# Honda Comments – CARB ONMC Rulemaking

## Regulation Language & Test Procedures

Honda Motor Co., Ltd.  
American Honda Motor Co., Inc.  
January 16, 2024

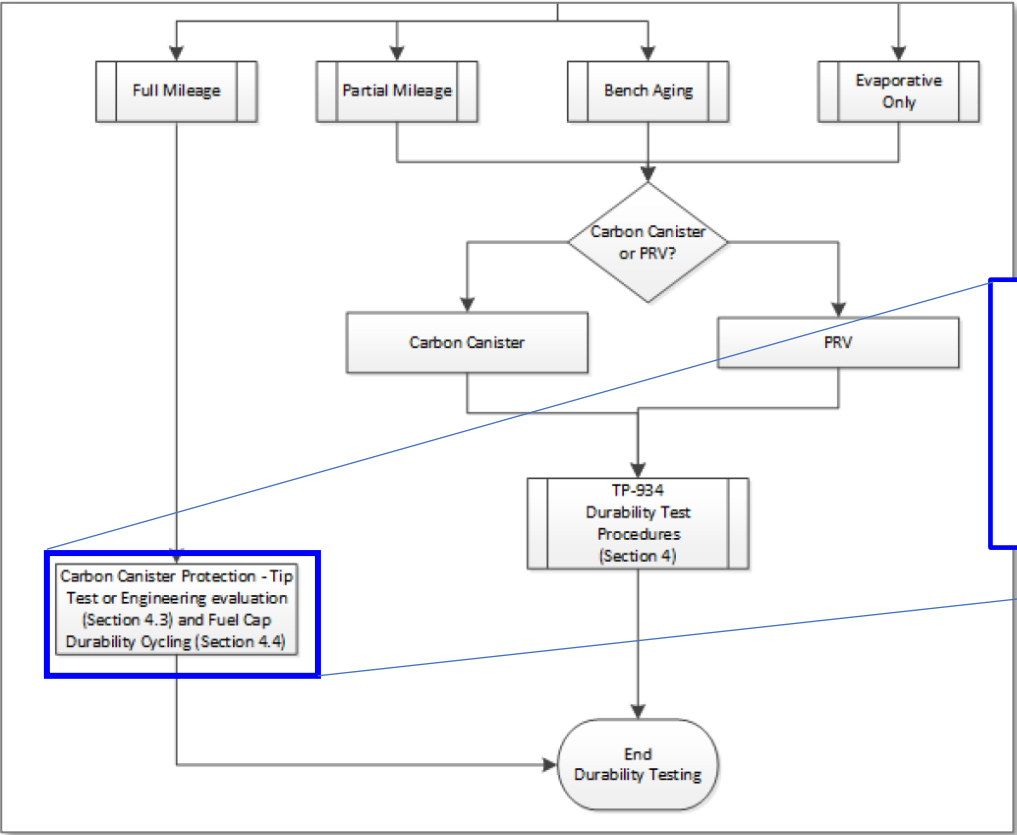
No.	Draft Legislation	Comment
APPENDIX B2 4	demonstrate that the alternative durability test procedures are representative of end of useful life. A vehicle that has completed the full useful life service accumulation with the evaporative components installed throughout the duration of service accumulation may be exempt from the vibration durability requirements (Section 4.1.1), whichever are applicable. Durability testing shall include the steps outlined in Figure 2.	<Proposal> If you perform full endurance with Figure 2, you will only need to perform 4.3 Tip Test and 4.4 Fuel Cap Durability Cycling. Therefore, if a full endurance test is carried out, 4.1 Carbon Canister Test and 4.2 Pressure Vent (Relief) Valve are considered to be omitted, but in the text on the left, only 4.1.1 is omitted, making it an unmatched condition. We also request that 4.1 Carbon Canister Test and 4.2 Pressure Vent (Relief) Valve be omitted.

We believe that carrying out a full durability test on a completed vehicle and testing it individually would require double testing, which is unreasonable.

Proposal statement

A vehicle that has completed the full useful life service accumulation with the evaporative components installed throughout the duration of service accumulation may be exempt from the **carbon canister test (Section 4.1)** and **PRV test (Section 4.2)**, whichever are applicable. Durability testing shall include the steps outlined in Figure 2.

Carbon Canister Protection - Tip Test or Engineering evaluation (Section 4.3) and Fuel Cap Durability Cycling (Section 4.4)

No.	Draft Legislation	Comment
APPENDIX B2 4	<b>Figure 2: Durability Flow Chart</b> Evaporative Only	<Confirm> What is the test procedure for Evaporative Only?

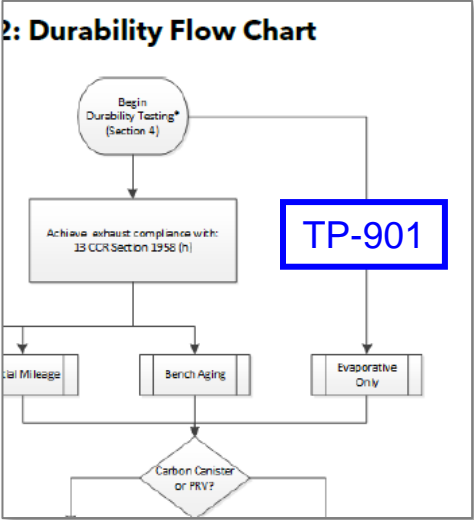
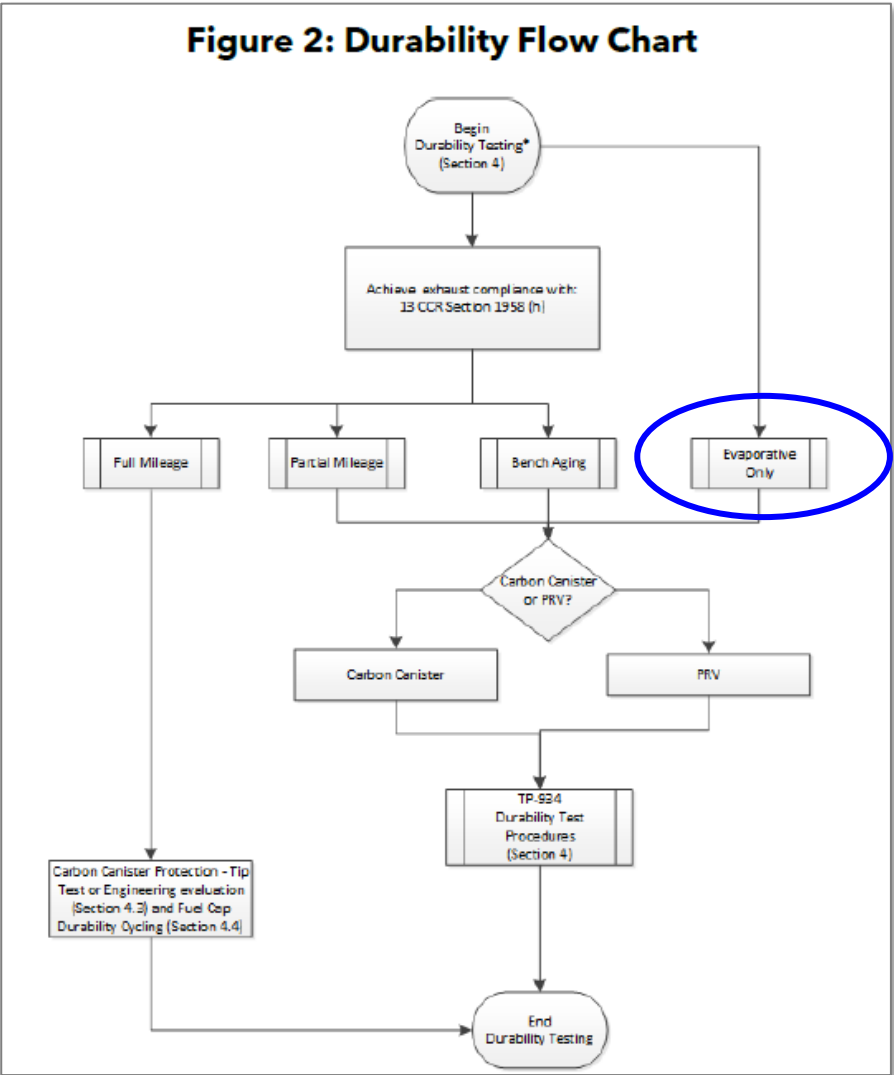
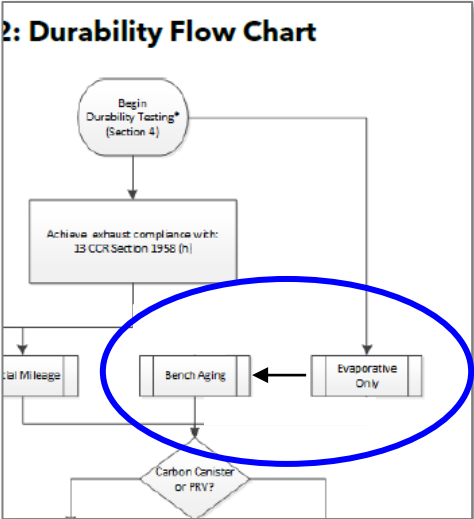
-Are you talking about a rig test using TP-901?

-Bench Aging refers to catalyst deterioration, so is it related to this?

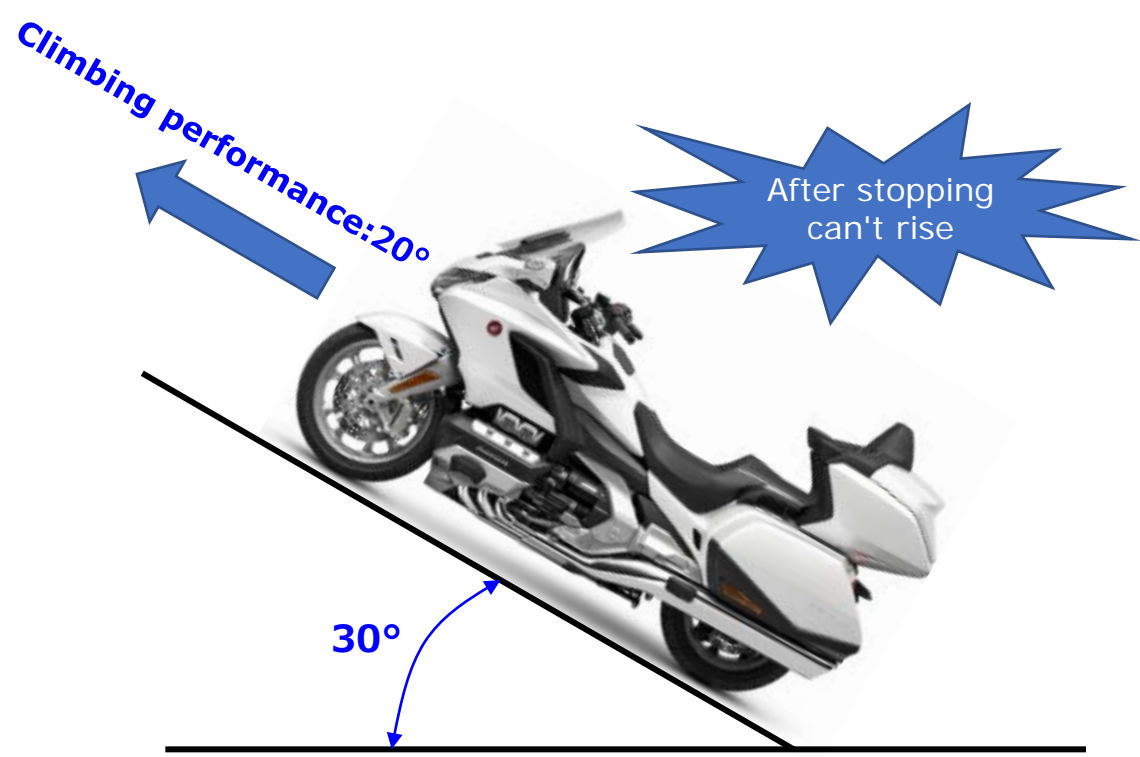
No.	Draft Legislation	Comment
APPENDIX B2 4.3 Carbon Canister Protection - Tip Test	4.3.1.1 In less than 5 seconds, orient the vehicle such that the travel axis is tilted X degrees above and below the horizontal plane. See Figure 3 for a schematic. Hold the vehicle for 60 or more seconds, or such longer period of time as a manufacturer may choose, in both the positive and the negative position. <b>X shall be defined as 30° ± 2° for two-wheel ONMCs</b> as identified in Figure 3 below.	<Proposal> When performing a TIP test on a heavy vehicle, restarting the vehicle after stopping in the middle of a slope may exceed its slope climbing capability (approximately 20 degrees) and may not be able to climb the slope, which is extremely dangerous. I would like to request that the requirements be relaxed and an angle that allows restart after a stop be added.

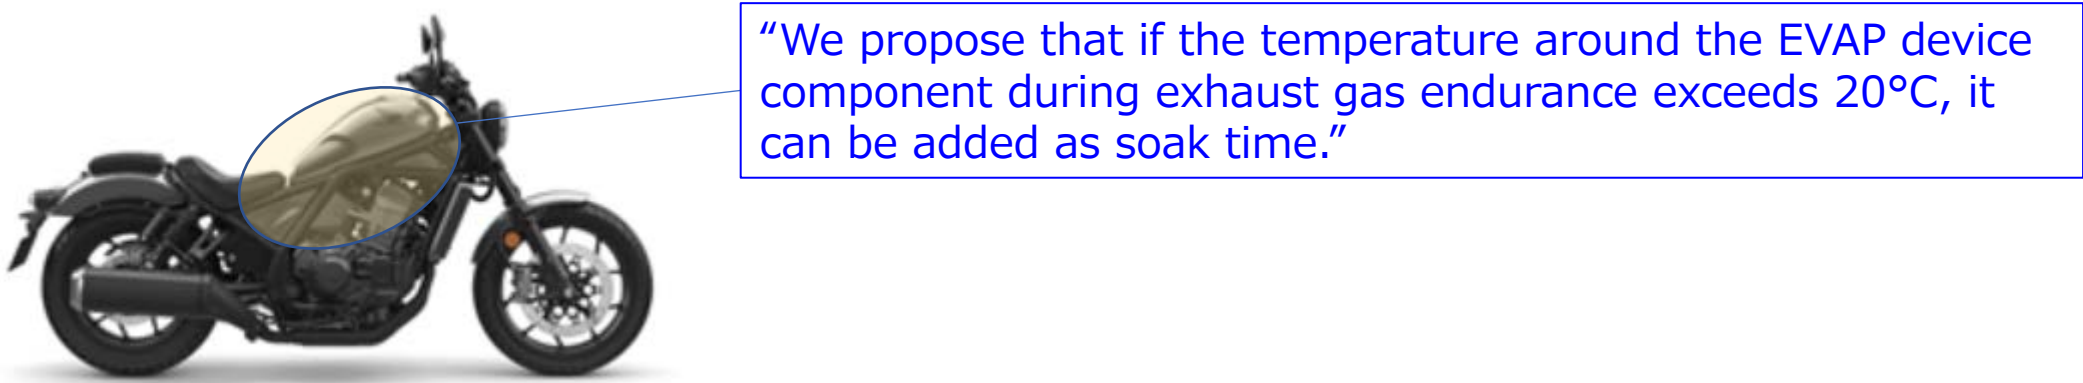
No.	Draft Legislation	Comment
APPENDIX B2 5.1	<p>a) Precondition the whole vehicle or fuel system rig continuously following one of the following 3 options defined below:</p> <p>1. Soak continuously for a total of 3,360 hours while maintaining an ambient temperature no less than 68°F;</p>	<p>&lt;Confirm&gt;</p> <p>If the endurance equipment is in ambient conditions, there may be cases where the ambient conditions are below 20°C. Since the EVAP component is mounted near the engine, when driving, the temperature of the EVAP component often exceeds the ambient conditions due to the engine’s exhaust heat. From the perspective of testing the durability of the EVAP component, if the temperature of the EVAP component exceeds 20°C, it can be considered as soak time. Therefore, is it possible to measure the ambient temperature near the EVAP component during endurance with a completed vehicle filled with E10 fuel?</p>

System figure of evaporative Emission control

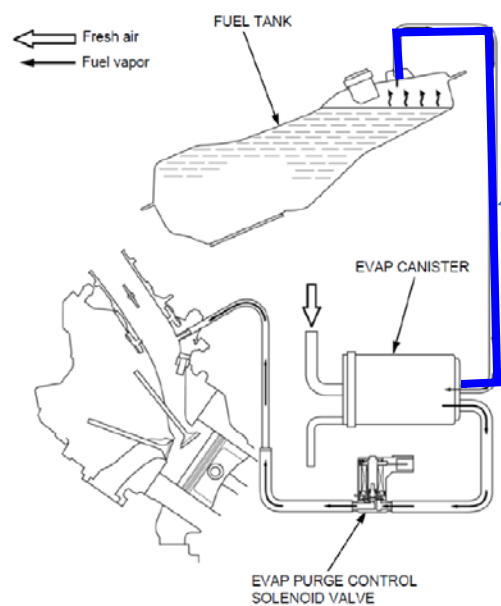
No.	Draft Legislation	Comment
APPENDIX B2 5.1	<p>d) Alternatively, the fuel tank, fuel line system, and/or vapor vent line system can be preconditioned as separate components from the whole vehicle as long as the reason for the separate component preconditioning is accepted by CARB prior to vehicle certification and the components are subjected to the equivalent preconditioning required for a whole vehicle. Acceptance will be based on verification of good engineering judgement used to ensure components are subjected to conditions similar to what would be found on the vehicle during preconditioning. These conditions include, but are not limited to, physical deformations, fuel fill volume for tanks, and fuel reservoir for fuel hoses and related components. <b>Vapor vent lines must be exposed to liquid fuel for component preconditioning.</b> This requirement only applies to separate component preconditioning and not to the fuel system preconditioning that is connected to filled fuel tanks. All components that are installed on the vehicle must be attached as it would be on a factory production vehicle.</p>	<p>&lt;Confirm&gt; It is difficult to immerse the vapor line in liquid fuel in the completed vehicle state. Is it okay to soak individual vapor line parts in fuel and then assemble them into the vehicle?</p>

“It is reasonable to conduct the test in the same condition as the completed vehicle (the vapor line is in the vapor state).”
